REDLINE 1 APPROVED 5/17/2012: *Dennis Dook*  
DENNIS DOOK, TEAM LEADER, TEDD

**SHA** STATE OF MARYLAND  
DEPARTMENT OF TRANSPORTATION  
STATE HIGHWAY ADMINISTRATION  
OFFICE OF TRAFFIC & SAFETY  
TRAFFIC ENGINEERING DESIGN DIVISION  
US 1 (BELAIR RD) @ PERRY HALL MARKETPLACE/  
NORTHVIEW SHOPPING CENTER ENTRANCE

**RAMP DETAIL SHEET**

TS NO. 3986 A DRAWING SG-2 OF 2 SHEET NO. 2 OF 2

**EQUIPMENT LIST**

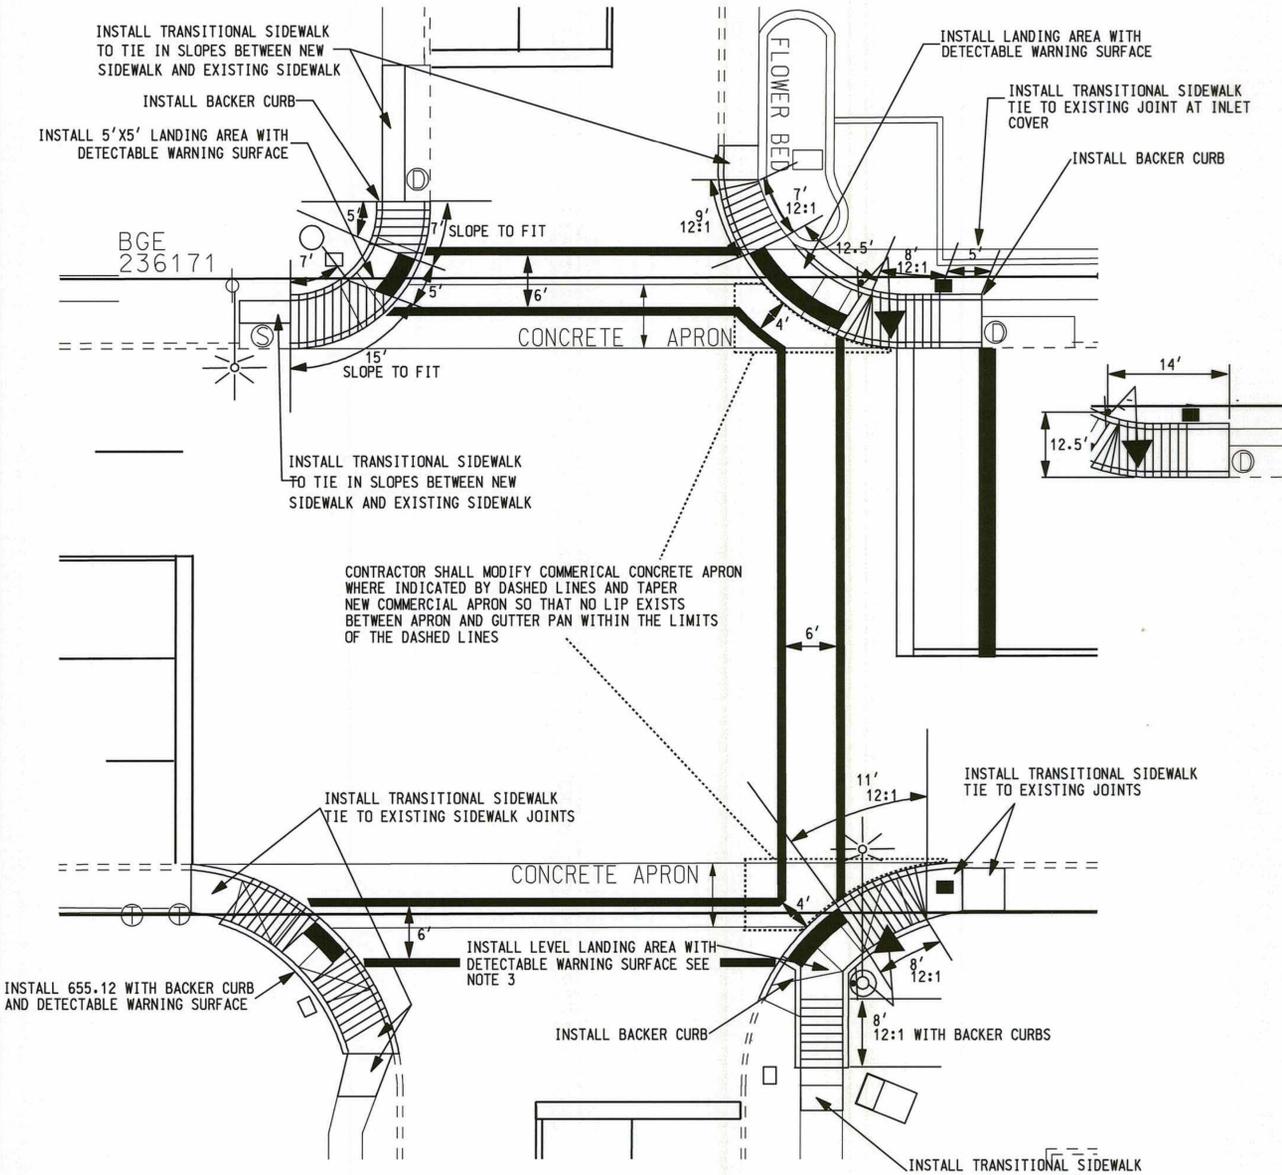
A. EQUIPMENT TO BE FURNISHED BY STATE HIGHWAY ADMINISTRATION		
NONE		
B. EQUIPMENT TO BE FURNISHED AND/OR INSTALLED BY CONTRACTOR		
ITEM NO.	QUANTITY	DESCRIPTION
1001	1 EA	MAINTENANCE OF TRAFFIC
2002	1 CY	TEST PIT EXCAVATION
5001	<del>50</del> LF 0	REMOVAL OF EXISTING PERMANENT PAVEMENT LINE MARKINGS
5004	225 LF	F&I 12" WHITE PREFORMED THERMOPLASTIC PAVEMENT MARKING
5005	<del>35</del> LF 0	F&I 24" WHITE PREFORMED THERMOPLASTIC PAVEMENT MARKINGS
6001	225 LF	F&I STANDARD TYPE A COMBINATION CURB AND GUTTER 12" GUTTER PAN 8" DEPTH
6002	725 SF	F&I 5" CONCRETE SIDEWALK
6003	60 SF	F&I DETECTABLE WARNING SURFACES FOR CURB RAMPS (TYPE 3 BRICK PAVERS)
8002	1 EA	F&I 2 WIRE CENTRAL CONTROL UNIT
8008	2 EA	F&I AUDIBLE/TACTILE PUSHBUTTON STATION AND SIGNS
8009	1 EA	F&I BREAKAWAY PEDESTAL POLE ANY SIZE
8015	2 EA	F&I 16" LED COUNTDOWN PEDESTRIAN SIGNAL HEAD
8023	1 EA	REMOVE AND DISPOSE OF EXISTING EQUIPMENT
8036	<del>70</del> LF 0	F&I UP TO 4" SCH 80 RIGID PVC CONDUIT-BORED

8038	35 LF	F&I UP TO 4" SCH 80 RIGID PVC CONDUIT-TRENCHED
8042	150 LF	F&I #6 STRANDED BARE COPPER GROUND WIRE
8053	<del>175</del> LF 315 LF	F&I ELECTRICAL CABLE-2 CONDUCTOR #14AWG
8055	<del>175</del> LF 315 LF	F&I ELECTRICAL CABLE-5 CONDUCTOR #14AWG
8000-NEG	2 EA	F&I CONCRETE COMMERCIAL ENTRANCE
8038	70 LF	F&I UP TO 4" SCH 80 RIGID PVC CONDUIT-TRENCHED
8046	1 EA	F&I ELECTRICAL HANDHOLE
